Al Bilal Mosque, Bury Old Road, Prestwich

Parking Capacity Assessment

Our reference: OP/240049/TN01

Parking Survey

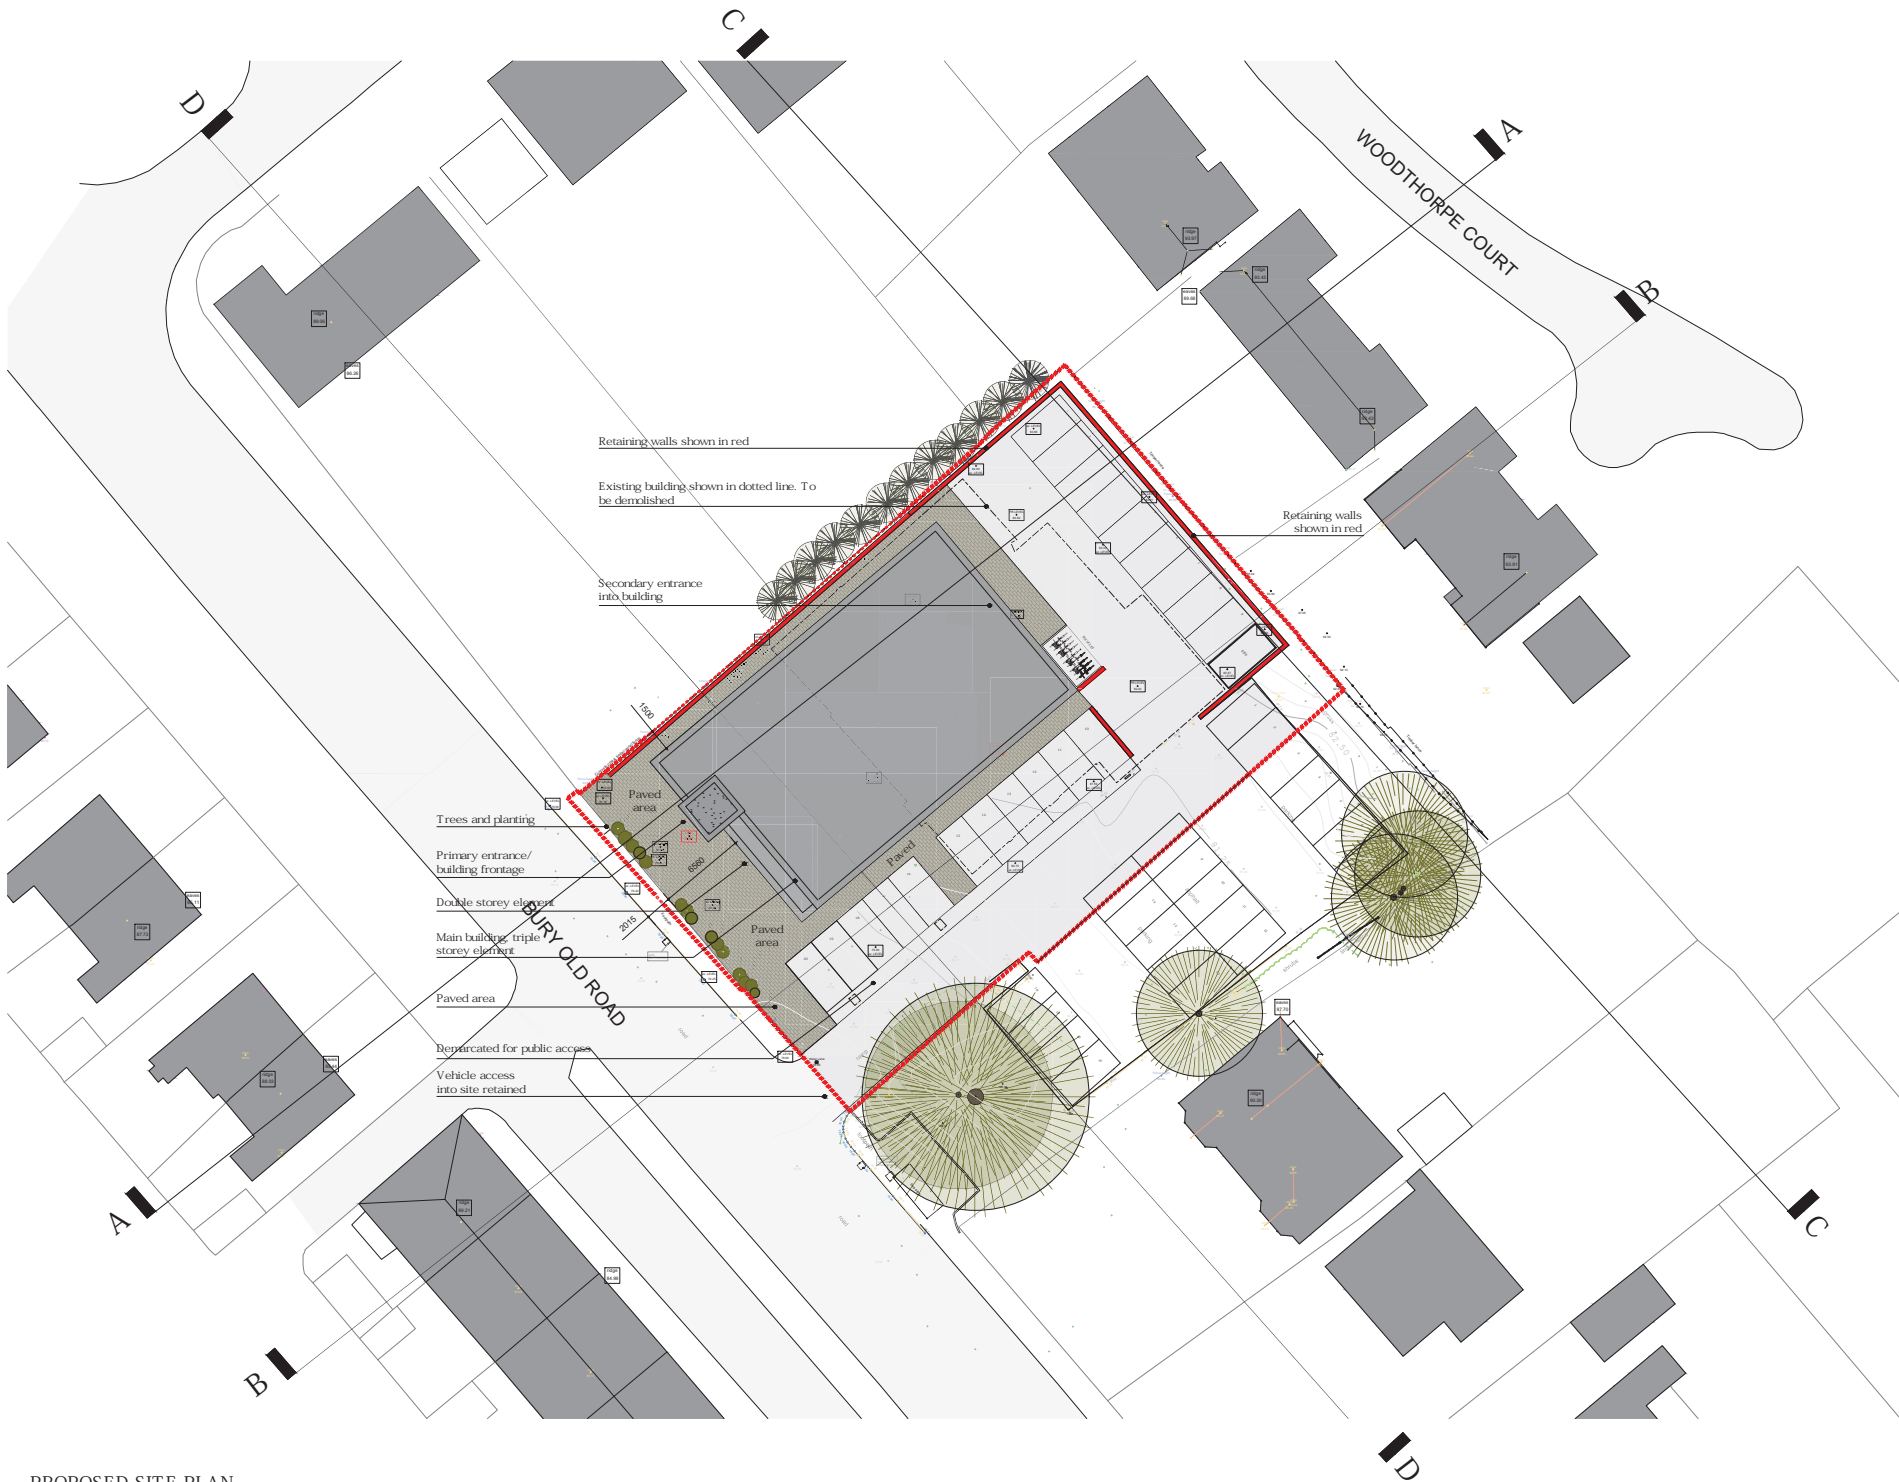
15. The recent parking survey results show that on a Friday which is the busiest time for the mosque, the six parking spaces at the access to the mosque were only fully occupied between 12.00 and

13.30. Similarly, the car park in front of the mosque was fully occupied between 12.30 and 13.30 with vacant spaces outside of this time period. The Brooklands public car park was fully occupied at 12.30 until 13.30. See [Appendix B](#) for the survey results as well as the locations of the car parks mentioned.
